# William H. Farquhar Middle School Modernization

Staff Report Date 09/05/14

# \*A. William H. Farquhar Middle School Modernization and **Batchellors Forest Residential: Site Plan Amendment** No. 82008019C

# B. William H. Farguhar Middle School Modernization: Mandatory Referral No. 2014050

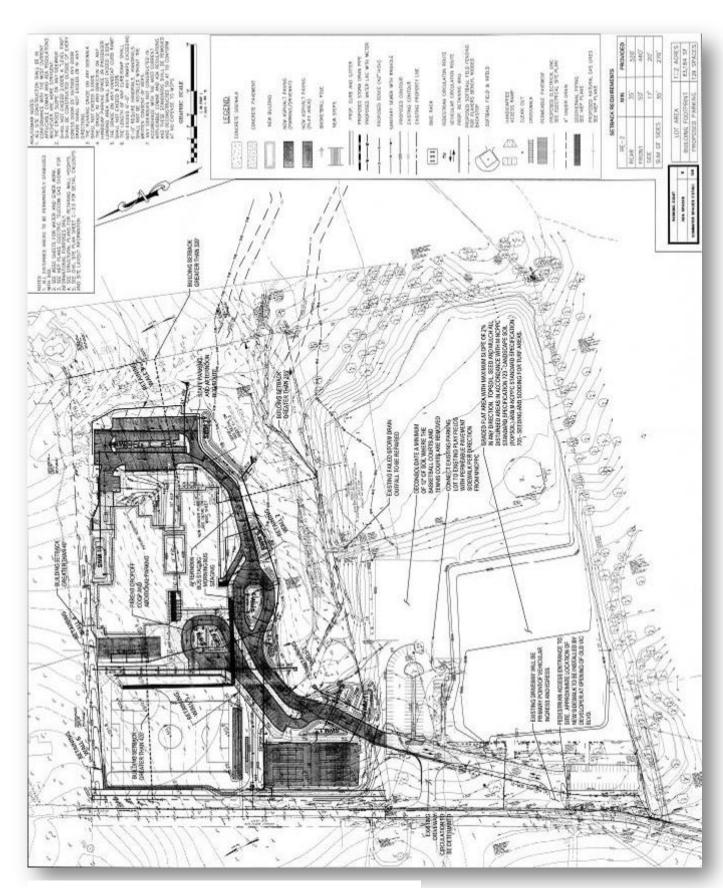
MR 2014028 set a single condition: MCPS had to submit a subsequent mandatory referral for both Parcel A and Parcel B that conformed to a Concept Plan included in the original submission. That Concept Plan is shown above. It shows the school located some distance from Batchellors Forest Road and it placed the school's playing fields and tennis courts along the road. It also shows the school's bus loop and parking facilities to the side and rear of the school nearer Parcel A. In this scheme, the house nearest the new school is next to playing fields, rather than the school building. Homes across Batchellors Forest Road see the school at a distance, across the fields. Woods separate the school and its parking from several homes to the east of the property.

The proposed Middle School plan shows that MCPS has based its design on the Concept Plan; the building, playing fields are similarly situated, and the school's circulation system remains to the south and east of the site.

Northern Elevation is nearest neighboring residences

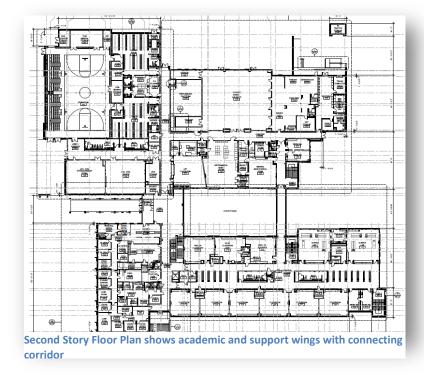
In addition, adjoining properties will face a one and one-half story section of the school, and, as noted, the building will be behind an existing forest stand. The northern elevation,

which is nearest a residential property, shows a varied roofline and includes views of the gymnasium. The three story section is some distance to the south from the nearest neighbors.
